# Moon Readywears Ltd.

Beron, Diakhali, Asulia, Savar  
(23.937438,90.299281)  
13 April 2014

# Observations

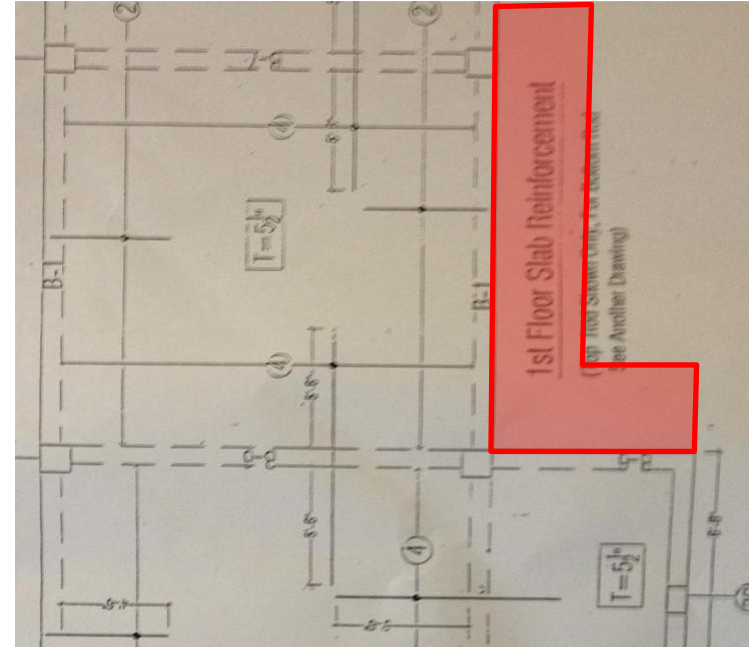
# Discrepancies between Design & Construction which affect Stability

## Undocumented Structure / As built discrepancies – Building 1

- A. As built edge of lift core and adjacent column do not align as shown on structural drawings. Beam cantilever created.
- B. From review of the level 6 soffit it is clear the beam support arrangement within the men's toilet area does not match other floors. Design load path at level 6 unclear.

D. Undocumented first floor slab cantilever noted above in red. Similar cantilever is reflected in roof above. Deflection induced distress observed in non structural elements. Concrete cracking in roof perimeter downstand likely induced by hanging load path to cantilevered roof edge.

- Undertake a detailed as built survey of building 1 and 2 recording all undocumented structures and extensions.
- Record relevant materials used in construction.
- Building engineer to check design where discrepancies exist. Design appropriate strengthening and/or additional support as required.

- Construct strengthening and/or additional support specified by the building engineer.
- Complete as-built drawings for buildings 1 and 2 incorporating any remedial or strengthening works undertaken.

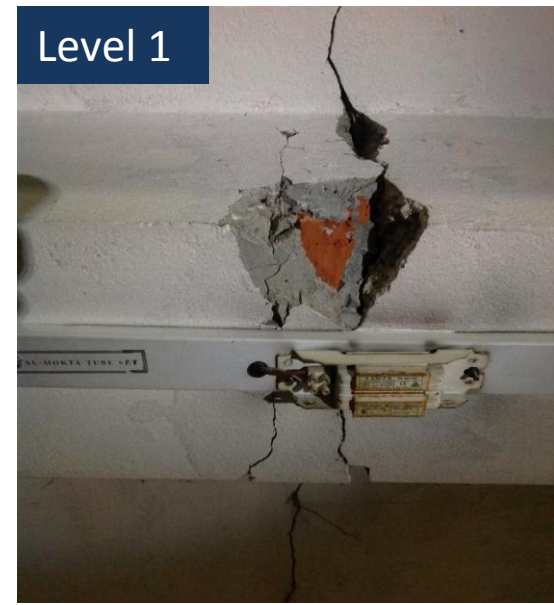
- Structural design documents specify an expansion joint at all floors.
- Expansion joint filled with brick/render finish at level 1 and 2.
- Expansion joint not constructed above level 3.
- Lateral system design may not account for forced compatibility at levels where joint not installed/ improperly installed.

- Building engineer to review design of lateral load support system and floor diaphragms.
- Design review to ensure in plane loading of diaphragms is considered. E.g. shrinkage and thermal effects in combination with lateral loads as appropriate.
- Building engineer to review façade and advise if any remediation is necessary to ensure structural sufficiency for the full design life.

- Construct strengthening and/or additional support specified by the building engineer.
- Complete as-built drawings for any façade or primary structure modified to incorporate remedial works undertaken.

Level 3 façade

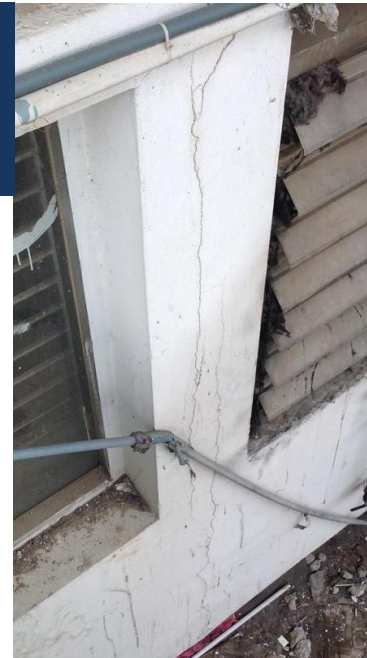
- Distress evident where façade bridges across movement joint.
- Distress in beams and slabs evident where movement joint not installed. Number and size of cracks is maximum at roof where thermal load magnitude is highest.

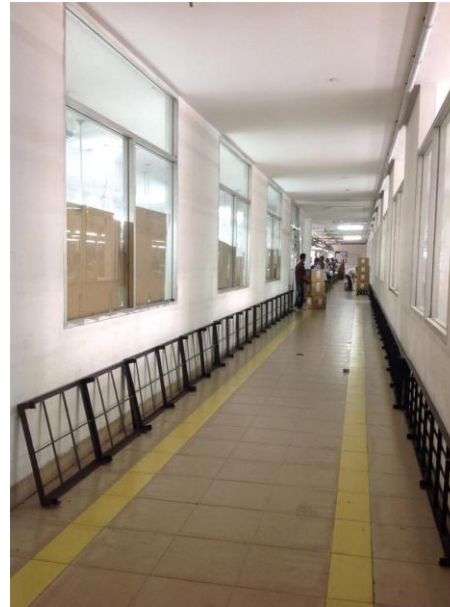
- Floor load management system incomplete as no loading plans observed at the suspended floors.
- Localised areas of storage loading.
- Heavyweight internal brick partitions constructed on suspended floors.

- Building engineer to produce loading plans to be displayed at each floor level. Allowable load allowance to be calculated considering existing super imposed dead loads (E.g. floor finishes and partition walls). Factory manager to actively manage floor usage in accordance with the loading plan.
